<b>Docket Number:</b>	21-DR-01
<b>Project Title:</b>	Supply Side Demand Response
<b>TN #:</b>	248194
<b>Document Title:</b>	Josh Bode Comments - DSA Comments on CEC Draft Report Qualifying Capacity of Supply-Side DR
<b>Description:</b>	N/A
<b>Filer:</b>	System
<b>Organization:</b>	Josh Bode
<b>Submitter Role:</b>	Public
<b>Submission Date:</b>	12/20/2022 6:10:05 PM
<b>Docketed Date:</b>	12/21/2022

**DSA Comments on CEC Draft Report Qualifying Capacity of  
Supply-Side DR**

## CEC Qualifying Capacity of Supply-Side Demand Response Working Group Final Report Comments

Prepared By: Demand Side Analytics

Figure 2: Overall, Alignment of Proposals with Working Group Principles as Scored by Stakeholders

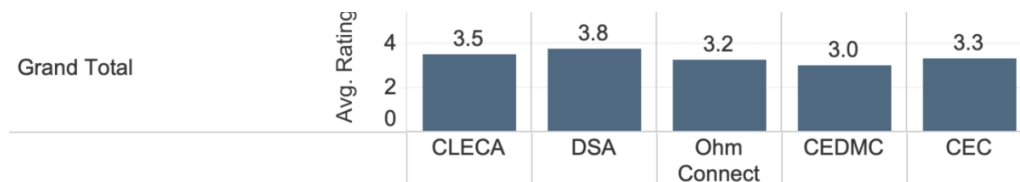
- **The CEC report ignored how proposals aligned with the working group principles as scored by the workshop stakeholders.** The feedback provided during the workshop by the stakeholders did not favor the CEC proposal. All the stakeholders were invited to rank how each of the proposals submitted aligned with the agreed-on principles by the stakeholders. The majority of stakeholder entities replied to the survey. The eleven (11) respondents are shown in the table below (Table 1) and include a wide range of perspectives and interests. The stakeholders, as a group, definitively scored the two proposals that built on existing load impact protocols the

highest based on agreed upon principles. When the stakeholder survey results were revealed, the moderator – who submitted their own proposal and scored the proposals – repeatedly insinuated that stakeholders must have misunderstood the principles and attempted to re-score the results, which ranked the CEC and CEDMEC proposals the lowest. This is remarkably unusual. In their report, the CEC summarily dismisses the stakeholder feedback and preferences. The stakeholders were not confused by the principles, they simply interpreted the principles and applied them to the proposals. What the CEC did not mention in their report is that there were numerous meetings debating the principles and their wording. Everyone scoring the proposals had the context, knowledge, and expertise to identify how well the proposals aligned with the principles. In their report, the CEC does not discuss the alignment of their recommendation with the working group principles. It insinuates that it incorporates other proposals, but at its core, it is the CEC commissioner advisor’s proposal with minimal substantive modifications. It does not reflect a consensus or the positions from the working group.
